## PLANNING COMMISSION MEETING STAFF REPORT

**NAME OF PROJECT:** Homestead Villas: Phase 1 of the Homestead Resort Master Plan

Subject: **The Homestead Villas Plat A and B; Preliminary Review**

**HOMESTEAD VILLAS PLAT "B"**  
 LOCATED IN THE NW CORNER OF SEC. 34, T3S, R4E, S18&M  
 MIDWAY CITY, WASATCH COUNTY, STATE OF UTAH  
 SCALE: 1" = 30' FEET

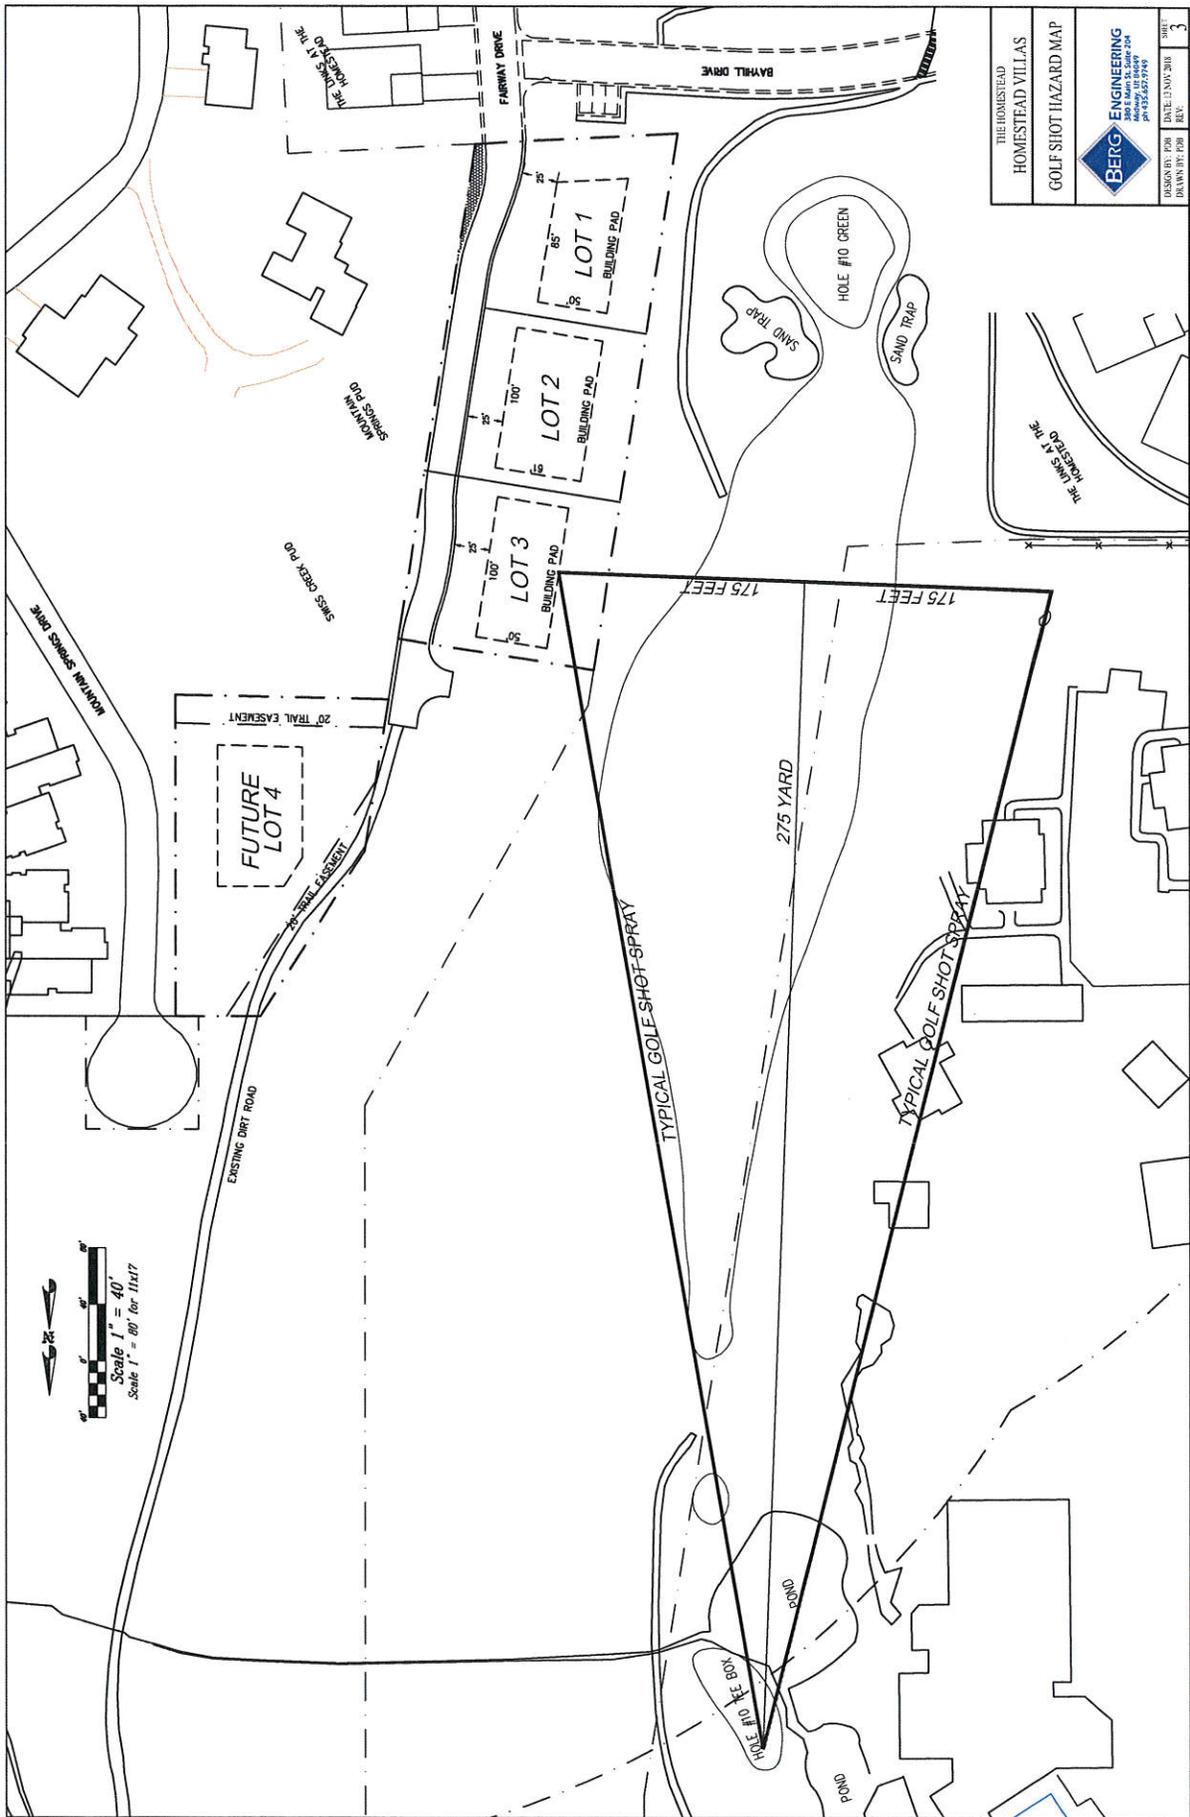
- To better protect the erosion of the existing area, the 20' private road within Plat A should have curb & gutter installed on each side of the road.
- A hammer-head turn-around is proposed at that the end of the private drive.
- Lot 4 as currently shown in Plat B has an easement strip between it and the existing Mountain Springs Drive. This easement should be recorded with the recording of plat B.
- The property boundary of lot 4 is over the existing dirt road connecting the dirt road to Mountain Springs Drive. Will this dirt road be re-located and the connection be continued?

THE HOMESTEAD  
HOMESTEAD VILLAS  
UTILITY PLAN

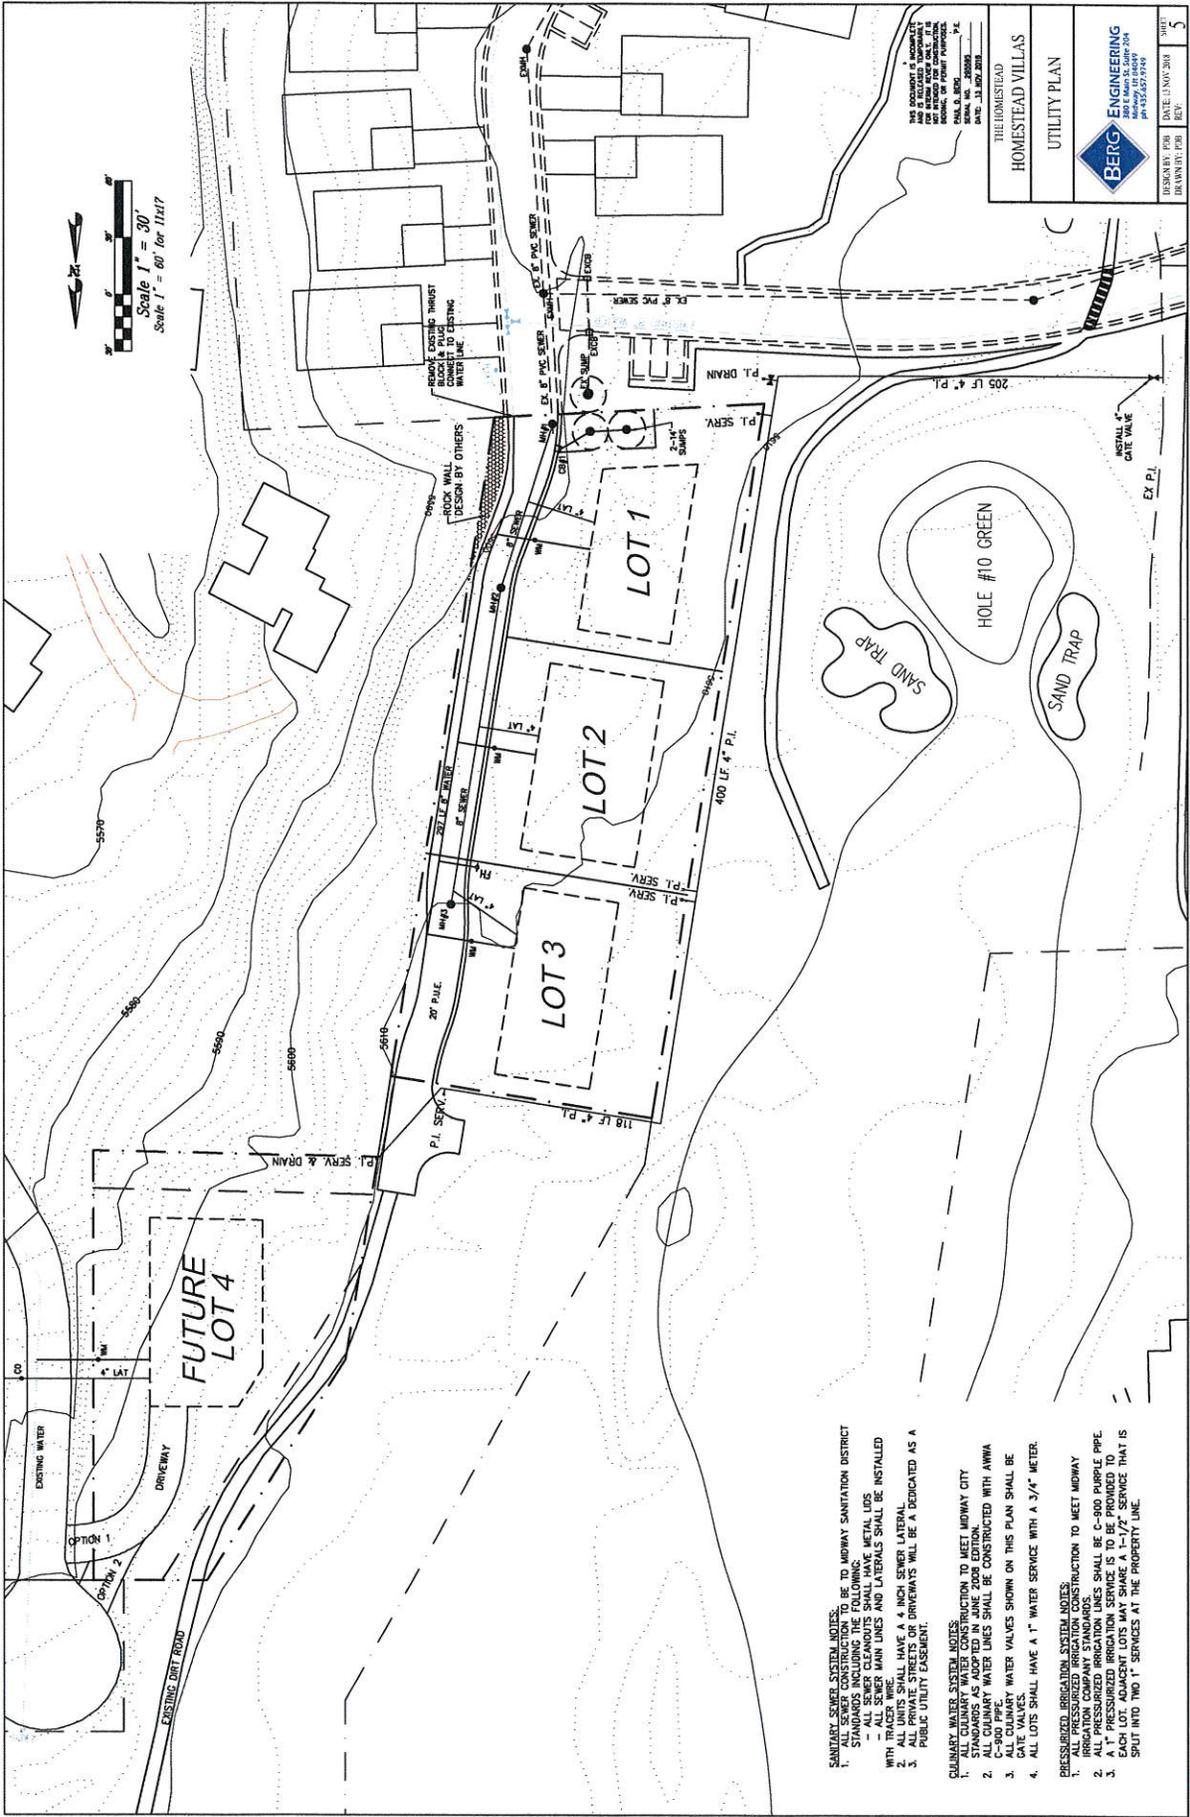
- The public waterline within the proposed development will connect to the existing 8-inch public waterline line in within Fairway Drive of the Links. Lot 4, which is within Plat B, shows a lateral connecting to an existing line in Mountain Springs Drive.

- The proposed storm drain system contains two sumps. With the construction of the additional curb & gutter, the storm drain calculations should be updated. What type of soil will the sumps be constructed in? Is lot 1 proposed to have a basement that the proposed sumps could impact?
